**AMENDMENTS TO THE DRAWINGS**

**REMARKS**

This Amendment is a full and timely response to the Office Action dated August 26, 2005. Reexamination and reconsideration are respectfully requested.

FIG. 7

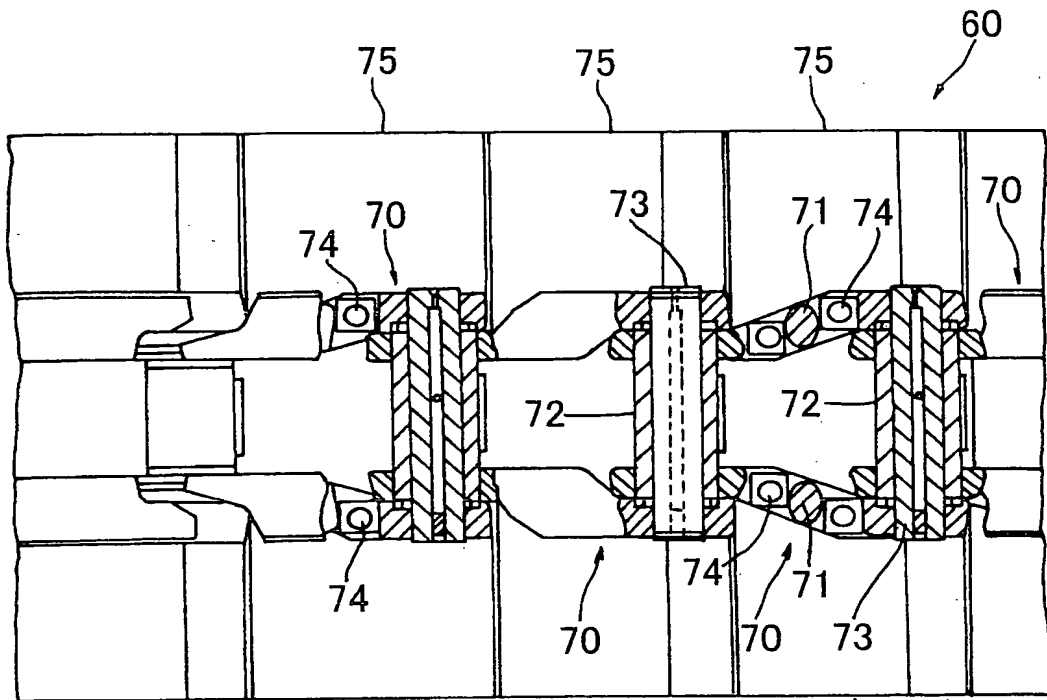
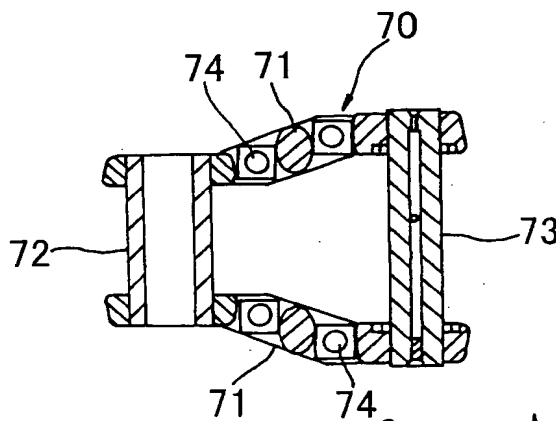
Sheet 1 includes Figs. 7(a) and 7(b) – Please add the legend -- PRIOR ART --;

The drawings have been amended as requested by the Examiner. Specifically, the Figs. 7(a) and 7(b) have been labeled as "PRIOR ART".
